Determination 2009/29

The fire alarm requirements for a tenancy situated in a new commercial building at 67A Courtney Road, Tauranga

Figure 1: Ground floor plan

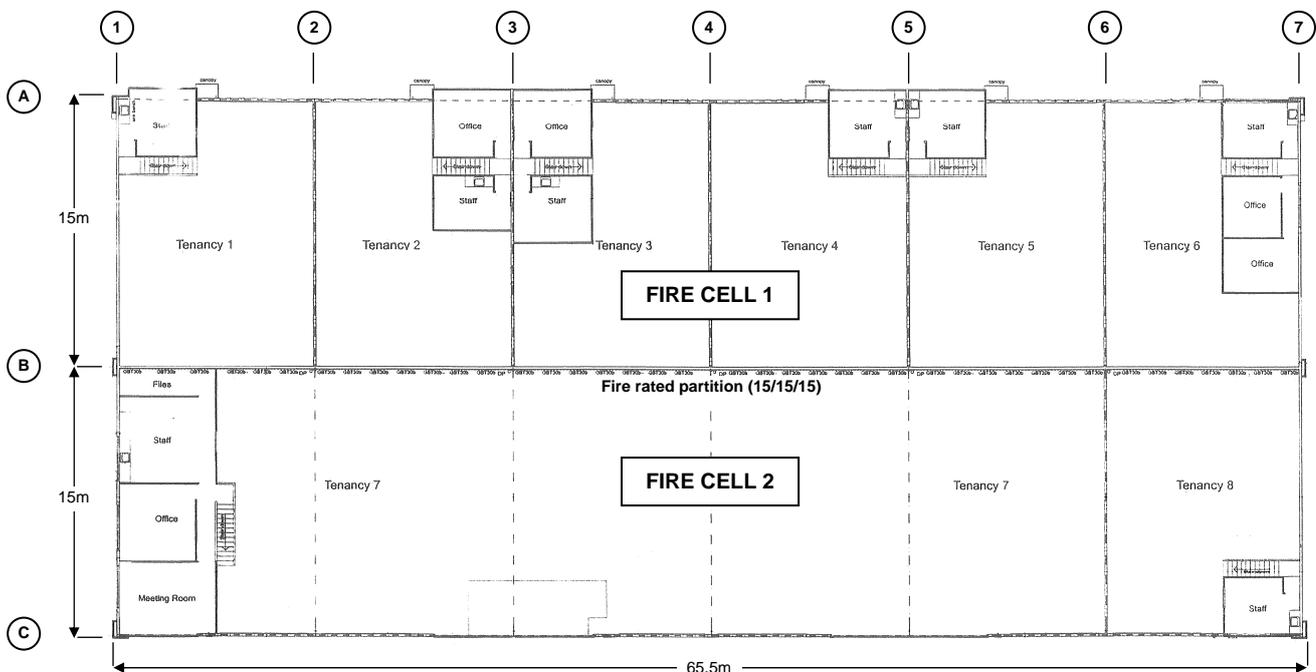
- 6.1.7 The inspection company is of the opinion that each tenancy is an individual smoke cell and accordingly that each tenancy is a firecell with an F rating of 10/10/-. Accordingly, as the mezzanine floor area of Tenancy 6 exceeds 20% of the ground floor area of that tenancy, the requirements of paragraph 6.21.6 of C/AS1 applies. This in turn would require the installation of a Type 4 fire alarm system.

- 6.1.9 As noted in paragraph 2.3, the area of the mezzanine floor in Tenancy 6 is 24% of the Tenancy 6 floor area, whereas the total mezzanine floor areas, taking into account the areas of each main firecell, are less than the 20% criterion.

6.2.2 However, a perusal of the plans leads me to believe that the true escape height is 2629 mm, based on the height from the ground floor to the height of the various mezzanine floors above the ground floor. Applying the fire-safety precautions set out in table 4.1 as against a WM purpose group I arrive at an F rating of F60. In terms of paragraph 5 of C/AS1, this would require the dividing wall between the two fire cells to be at least 60/60/60.

6.1.10 I do not accept the opinion of the inspection company that each tenancy is an individual smoke cell and therefore an individual firecell. In this respect I am of the opinion that there is no requirement for the individual tenancies to be separate smokecells and I agree with the submission from the applicant. As the overall mezzanine area in each of the two firecells is less than 20% of their overall area, clause 6.21.6 does not apply. This means that there is no necessity for a Type 4 alarm system to be installed in the building.

- does not require a type 4 fire alarm system to be installed
- does require either a type 2 alarm system or a type 3 alarm system installed depending upon the occupancy loadings agreed between the parties.
